HISTORIC PRESERVATION COMMISSION

Monday, March 2nd, 2026

**City of Avondale Estates  
Historic Preservation Commission  
COA Application Review\***

**City of Avondale Estates**  
**Historic Preservation Commission**  
**COA Application Review\***

Front

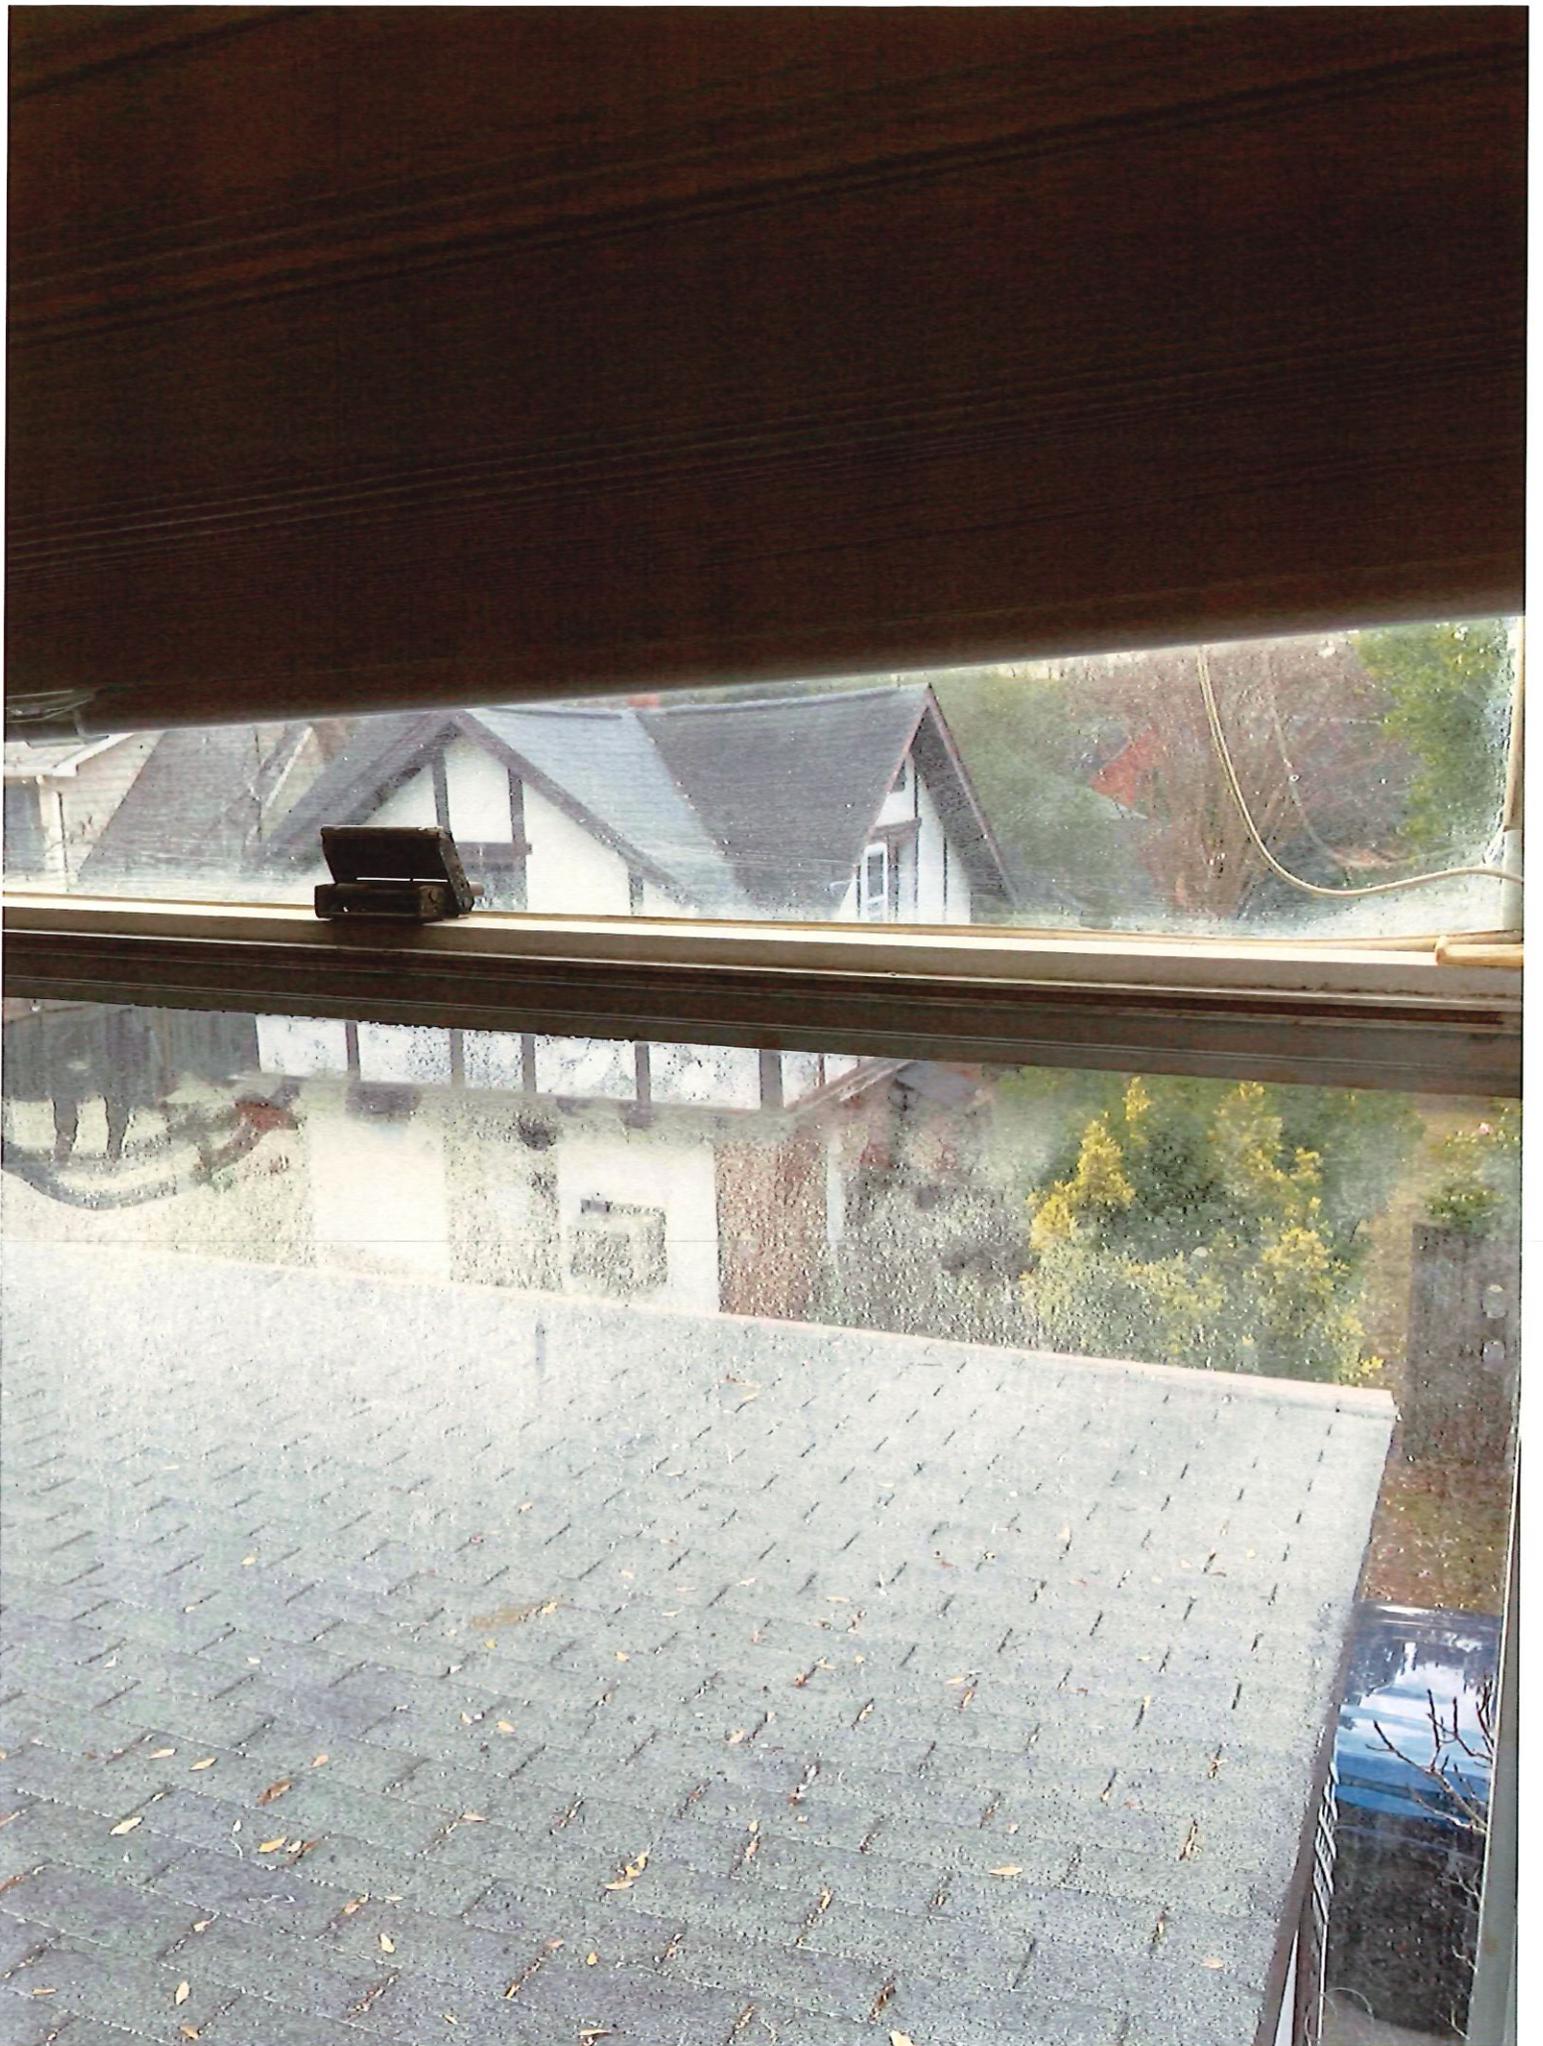
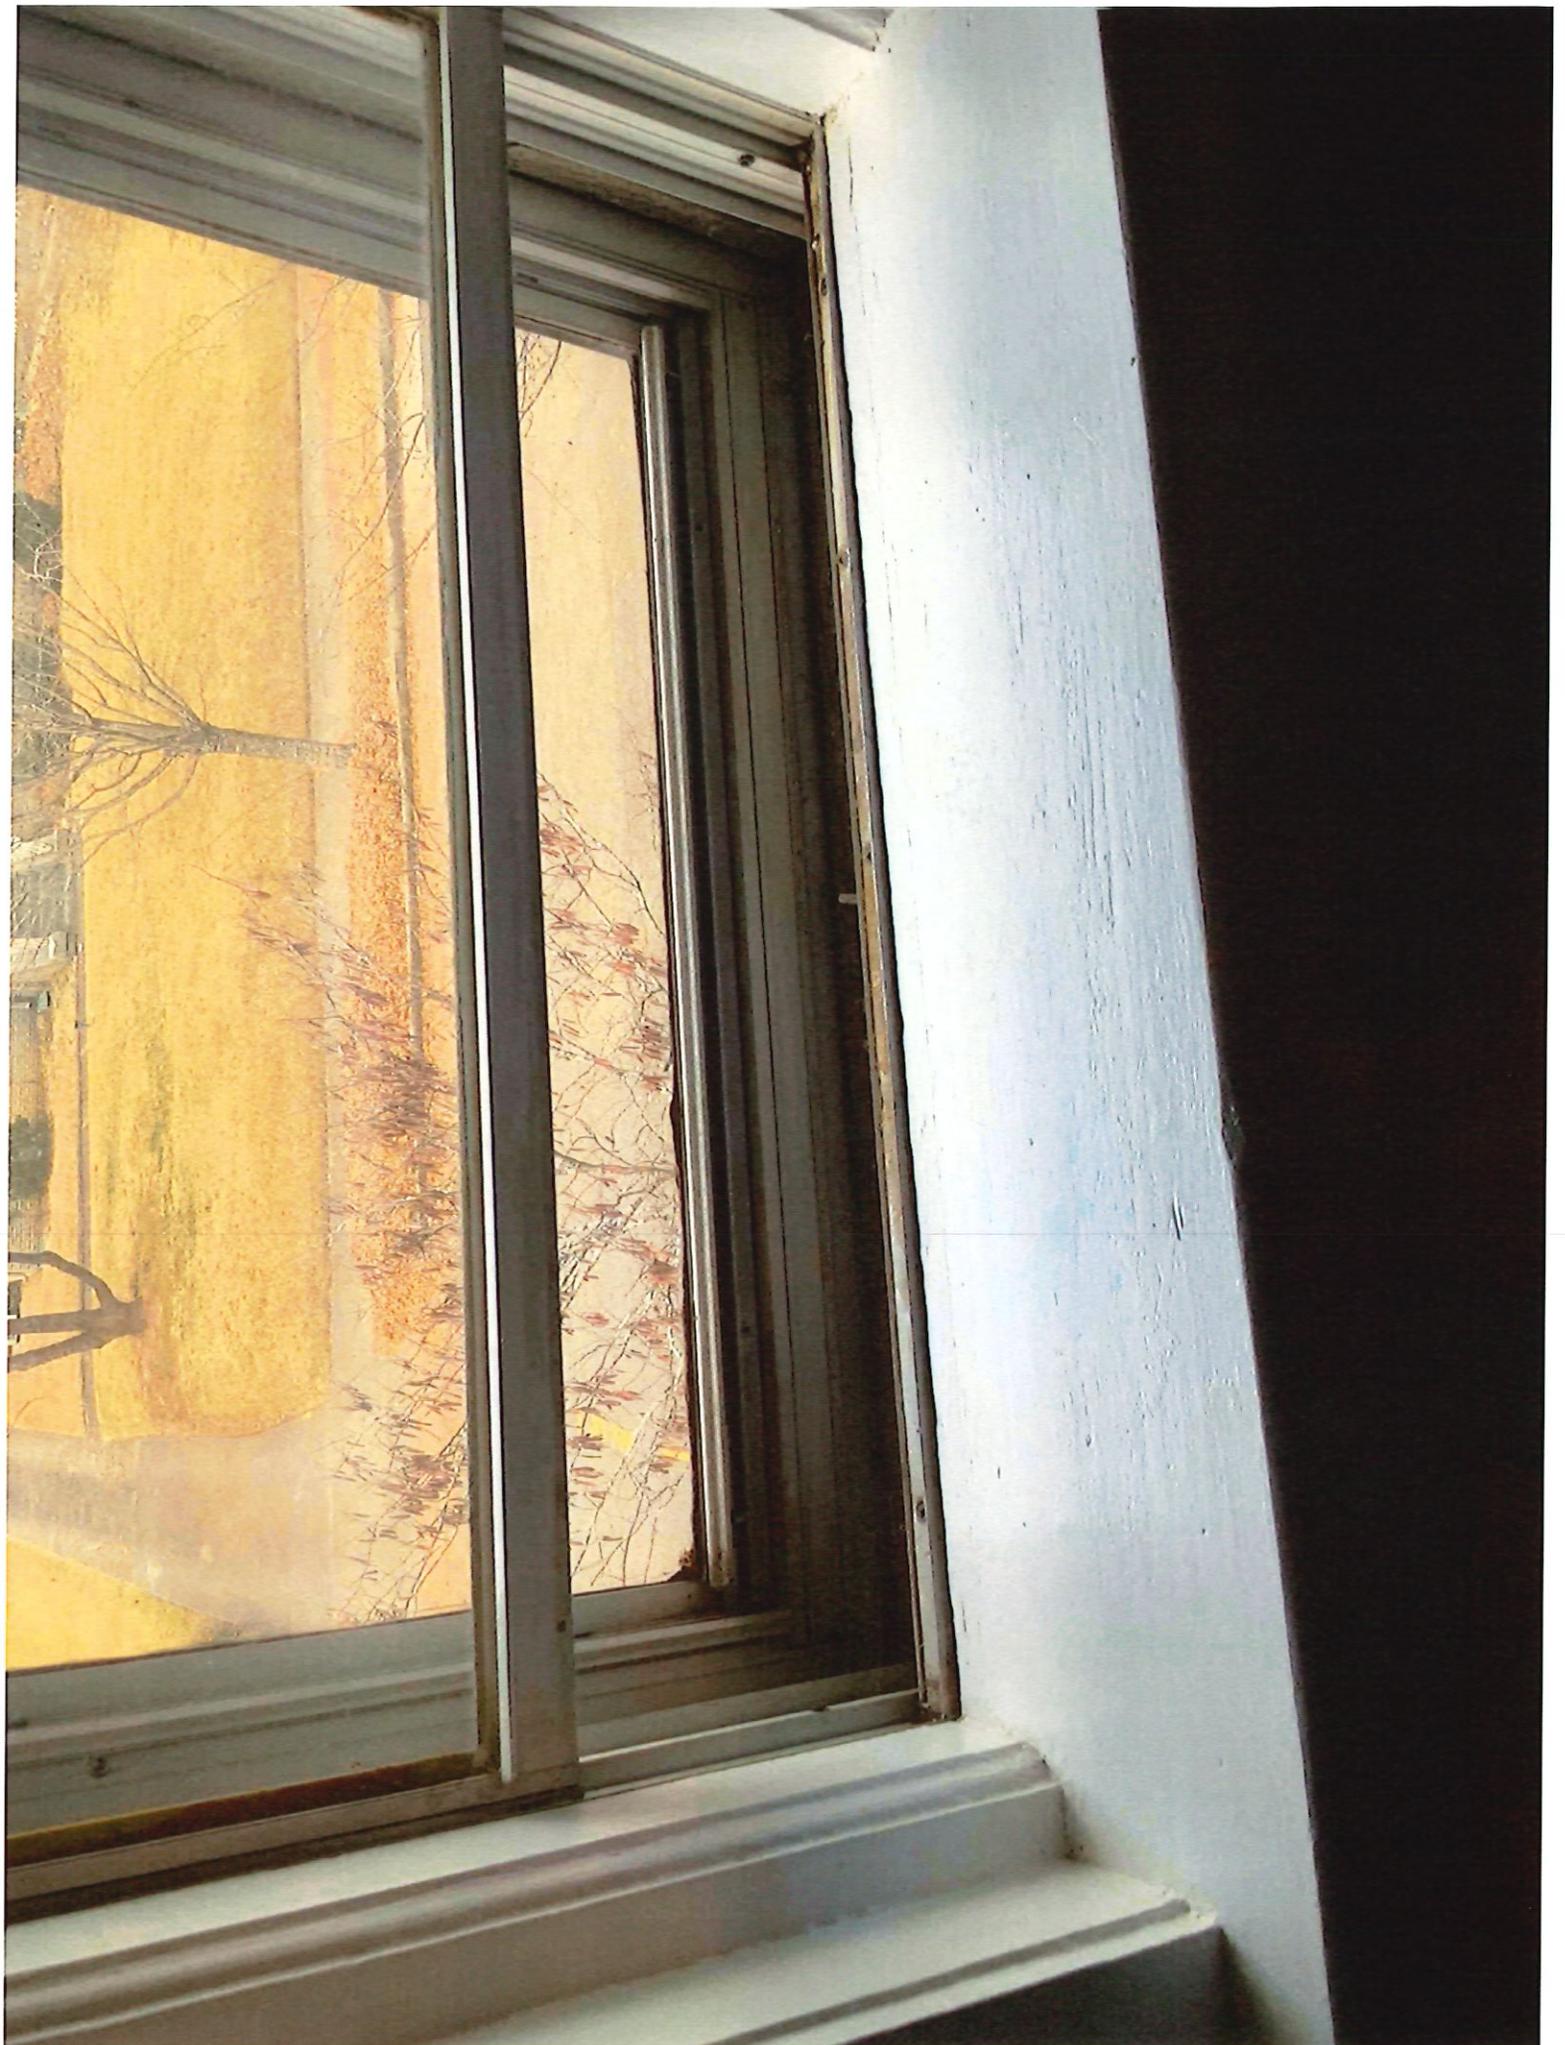
**Analysis:** The project proposes to replace five of the house's windows on the side and rear elevations. The five windows have been previously replaced and are not original to the house. These windows are 1-over-1, double-hung and appear to be a combination of metal, vinyl, and wood windows with storm windows. The proposed replacement windows will be wood with exterior cladding, 6-over-1, double-hung windows to match the appearance of the existing historic wood windows in the remainder of the house.

The windows proposed to be replaced are nonhistoric replacement windows. Therefore, the guidelines allow for them to be replaced. The proposed 6-over-1, double-hung windows may be TDLs or SDLs, and the rails, stiles, and muntin widths should match those of the house's existing historic 6-over-1 windows. The new windows' material should be wood without exterior cladding since synthetic materials are not allowed on original portions of Preservation Designation properties (see *Guidelines for Materials* below).

The *Historic District Guidelines for Materials on Preservation Designation* properties state that no new synthetic materials may be used on the original portions of Preservation Designation properties. Repair all components with the same materials. The proposed replacement windows should be wood without exterior cladding.

- Replacement windows should be wood without exterior cladding.
- Rails, stiles, and muntin widths should match those of the house's existing historic 6-over-1 windows.
